# Mallard Pass

## Mallard Pass Solar Farm

### Applicant's Response to Deadline 7 Submissions

EN010127/APP/9.47

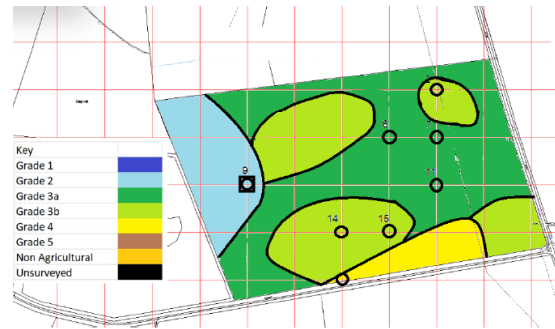
- 8.3 Landscape then report the field survey that they have carried out. As identified in section 5, a total of 8 samples were taken over the 30ha field. Field 2 is a variable field, as shown on the aerial photograph set out in the Landscape report.

8.5 Landscape then extrapolate their findings. The conclusion in 7.1 is that not all the BMV has been identified on the site (the implication is that they are referring to the whole Site not just field 2). It is stated that areas of Subgrade 3b that were not resurveyed (ie detailed survey) may contain some 3a or higher.

#### LANDSCOPE A

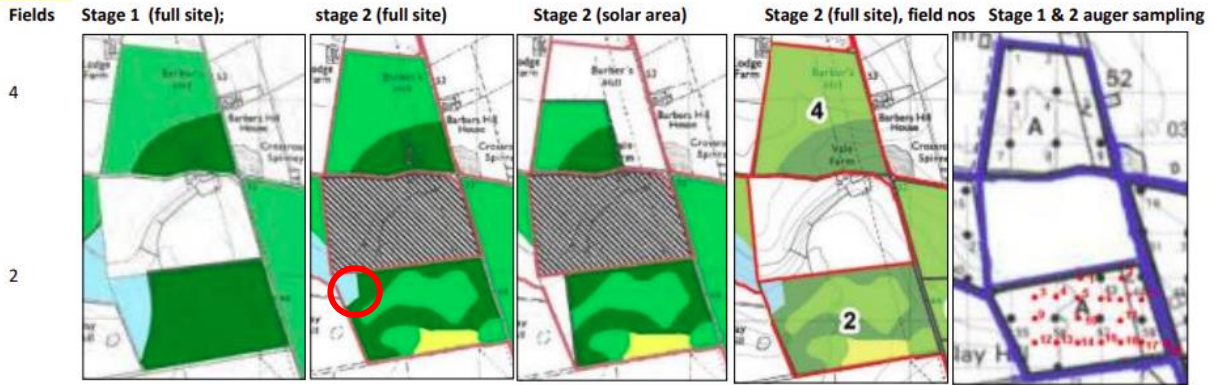
The change: the RHS of field 3 is mitigation as is the bottom of field 1

Comment: these plans all show the same area, bar a small area of Grade 2 (circled). That was mapped originally right up to auger point 27, which was a 3b position. The Applicant changed the boundary to match the field boundary. The area involved is about 0.5 ha.
